ADDENDUM NO. 2 12/12/2025

Request for Quotations 26-RFQ-004 – Etolin Heights Water Heater Replacement - Wrangell

ADDENDUM NO. 2

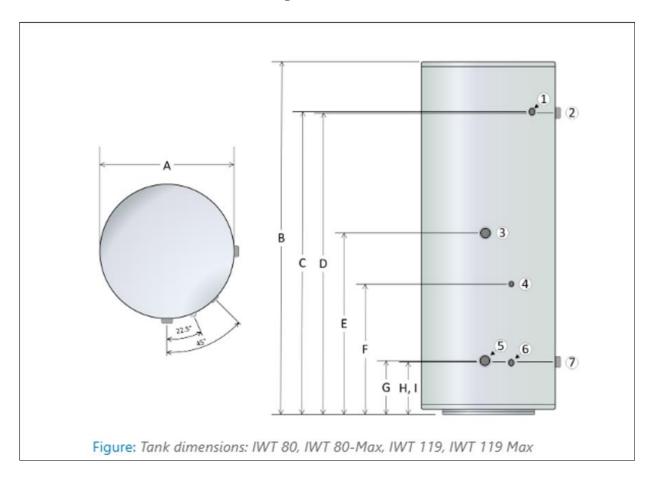
Please specify the location of "new low point drains on domestic and boiler piping". Does this mean they need to add a drain on the hot water heater side of the shut-off valve of the hot water supply so we can drain the pipes to the hot water heater and the heater water (coils)? Does the hot water heater include a hose thread hook up a hose to drain it? Can we add this if it does not? We like to drain them with a hose.

For the IBC IWT 119 (max) unit, all boiler and domestic water piping enters through the side of the unit.

As shown in the attached image, Port #5 is the designated low point connection for the boiler heating side. A low point drain shall be installed at or below the elevation of Port #5 to allow the heating loop to be fully drained.

As shown in the attached image, Port #7 (right side of the image) is the cold water inlet. The low point drain shall be installed at this location. Typical installation is for the cold water piping to drop down and, rather

than making a 90-degree turn directly into the tank, be installed with a tee:

- One side of the tee connects to the tank
- The other side connects to a low point drain valve

At each location where piping transitions into the boiler, the piping shall be configured with a tee and low point drain. This configuration is required so that both the domestic water side and the boiler/heating side of the unit can be fully drained if the unit needs to be removed.

Both the domestic-side low point drain and the boiler/heating-side low point drain shall be provided with hose-threaded drain connections suitable for attaching a hose.
